Meridian Firs Apartments

Deck Repair

Meridian Firs Apartments - Deck Repair
Puyallup, Washington
PRDK20241946

(Construction Plans, Sheet A1.1)

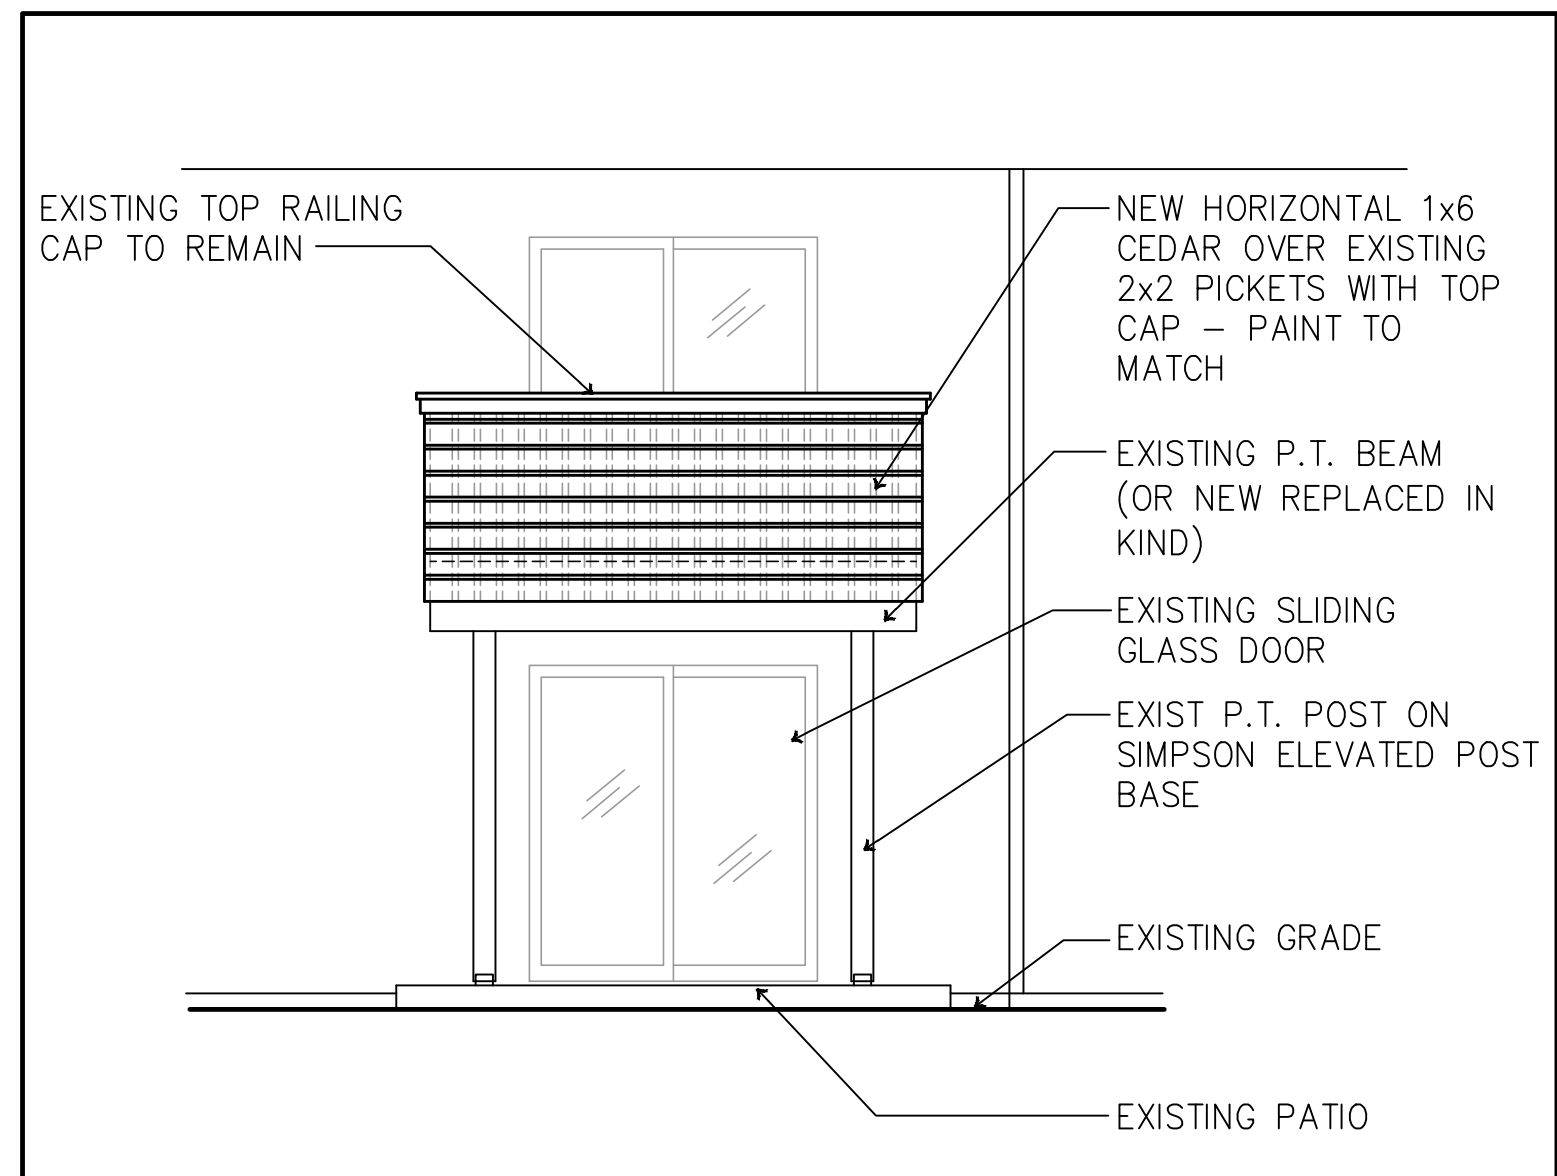
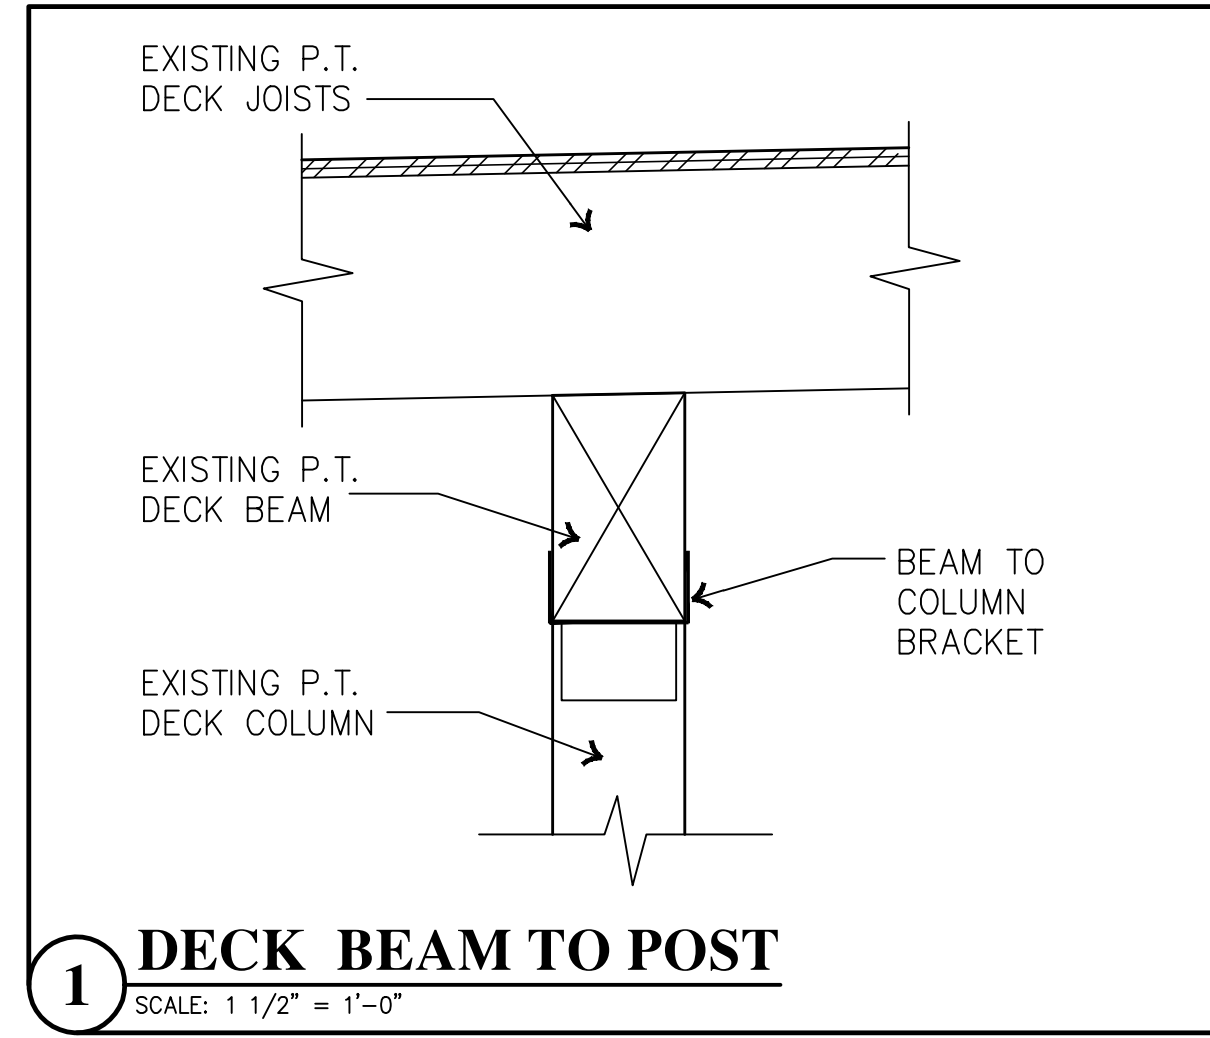
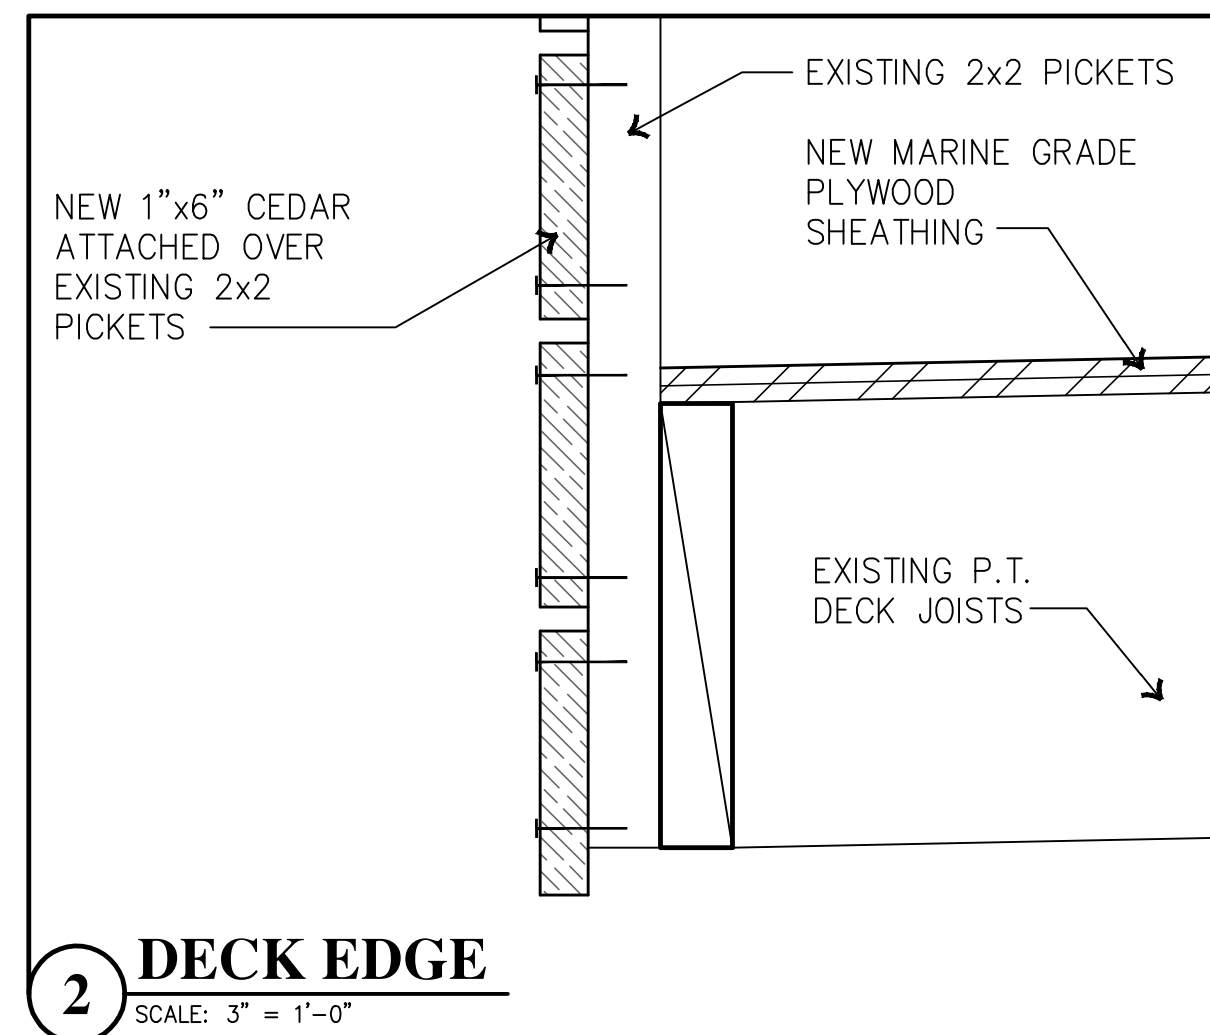
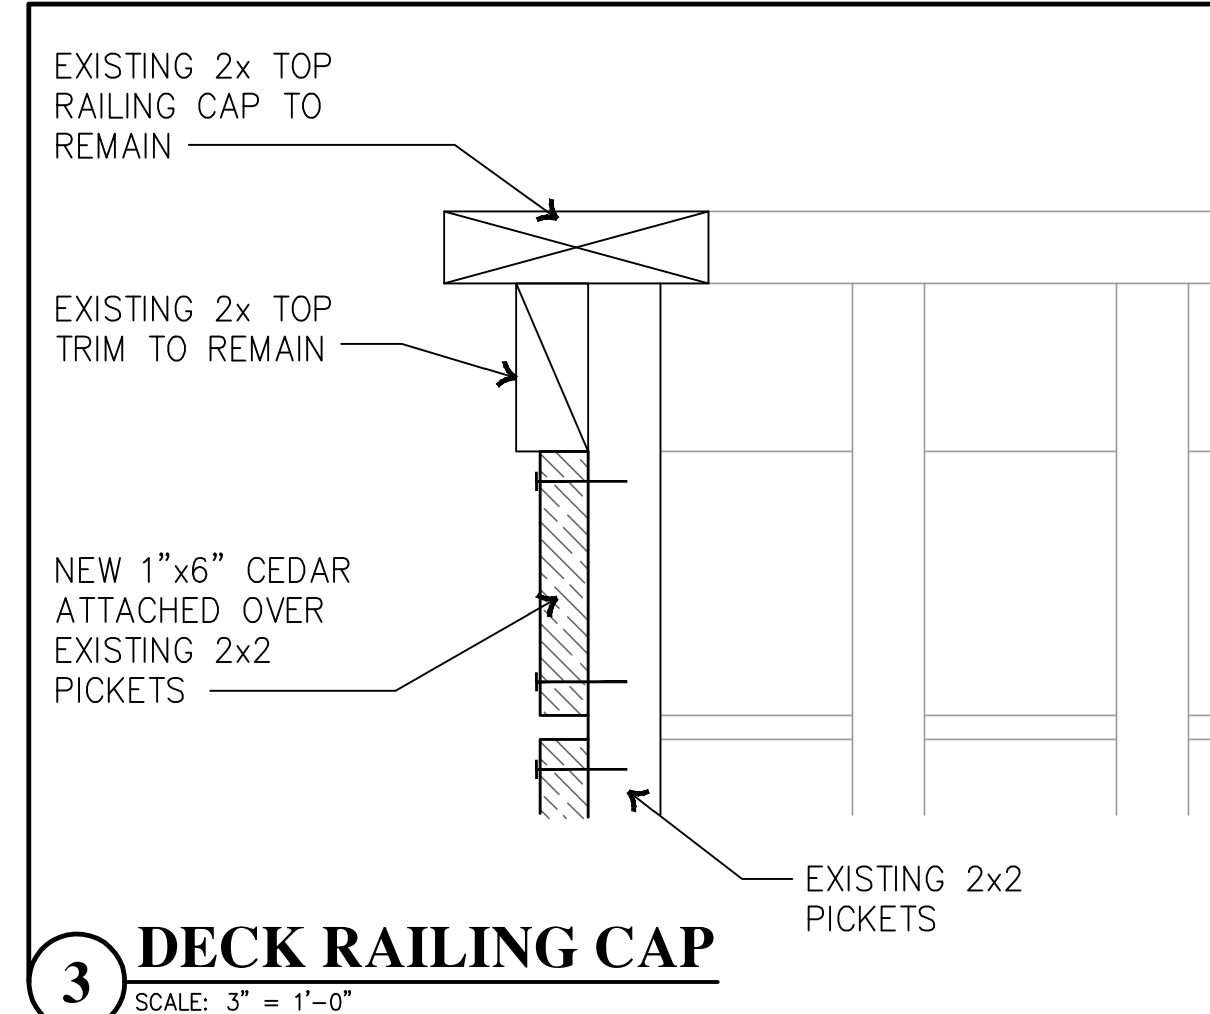
Deck joists appear to be sloped to drain off of the cantilevered side of each deck based upon details 1 and 2. Detail 2 shows the installation of the 1x6 cedar board over the existing 2x2 balusters. detail or notate how the 1x6 cedar will be installed to prevent drainage and water accumulation on the deck surface.

Add a notation on either Sheet A1.0 or A1.1 that contractor shall verify the integrity of balusters prior to the installation of the 1x6 cedar. Establish the parameters of the balusters replacement to include type, grade and nailing pattern.

Provide specifics of the plywood that will be installed which should include plywood thickness, grade and any other specifics that will reflect that the plywood will withstand the dead and live loads of the deck. Identify the non-slip surface that will either be provided on the plywood or will be added to the plywood as part of construction, as notated on sheet A1.0, Owner/Contractor Coordination Notes.

The existing joist spacing should also be considered when selecting the plywood material that will be used. Please provide the existing joist spacing.

Typical Deck Elevation
SCALE: 1/4" = 1' - 0"

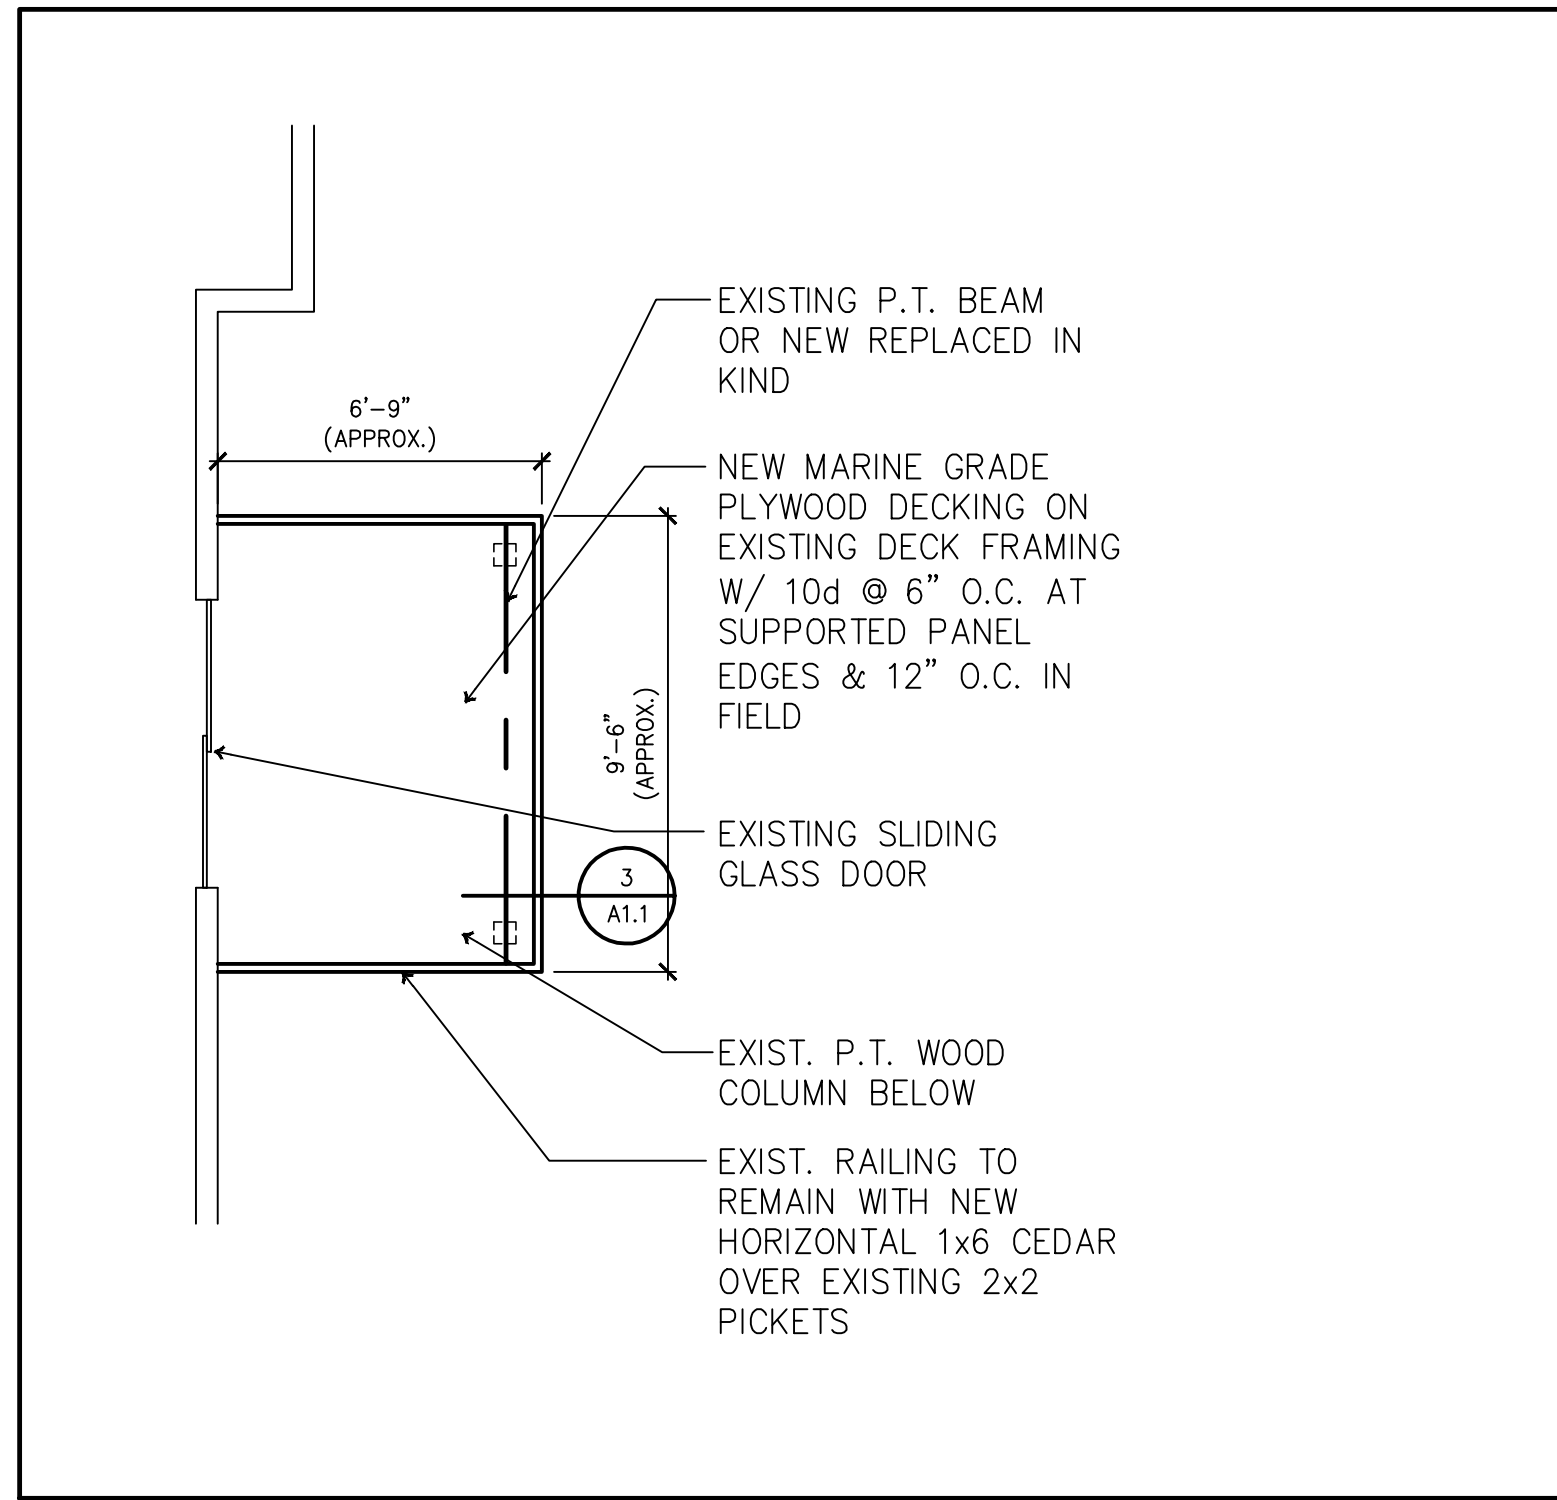
Determine the minimum required specifications for deck beams, posts, post bases, post caps and footings if replacements are necessary. Given the work already completed and the stop-work order in place, establish a clear benchmark to assess the completed work and provide clarity for future construction and inspection, minimizing any potential ambiguities.
